INDESIT company

Model type:
MT246

Commercial code:
F028993

Notices

n1025158: New central hinge for Ariston-55 2-door 240 litre refrigerators (Carinaro).

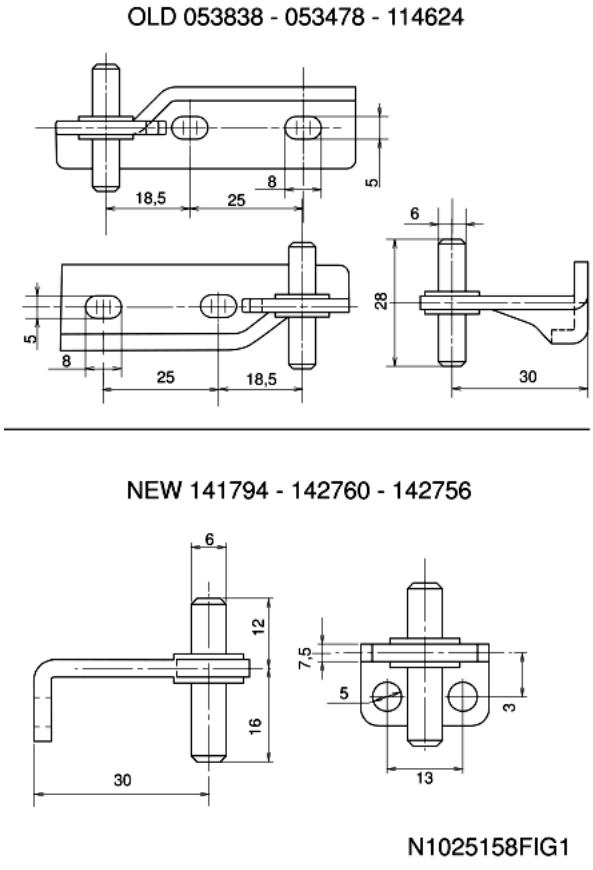
From serial no. 60123.0001, the Carinaro factory has modified the body of 240 litre refrigerators by introducing a new central hinge (see figure N1025058 Fig.1) attached to the side panel.
This hinge is still reversible but cannot be fitted on premodification models where the hinge was attached to the central trim of the refrigerator body (see Figure N1025058fig2).
When changing the door opening from right to left, the new hinge does not need to be inverted like the previous one, just moved to the left side.
To secure it, a hole must be made on the left side of the refrigerator body (see figure N1025058fig3).

141794 - POLAR WHITE CENTRAL HINGE (CARINARO)
142756 - POLAR WHITE CENTRAL HINGE (MANISA)
142756 - CHROME-PLATED CENTRAL HINGE

053838 - CHROME-PLATED CENTRAL HINGE
053478 - WHITE CENTRAL HINGE
114624 - POLAR WHITE CENTRAL HINGE
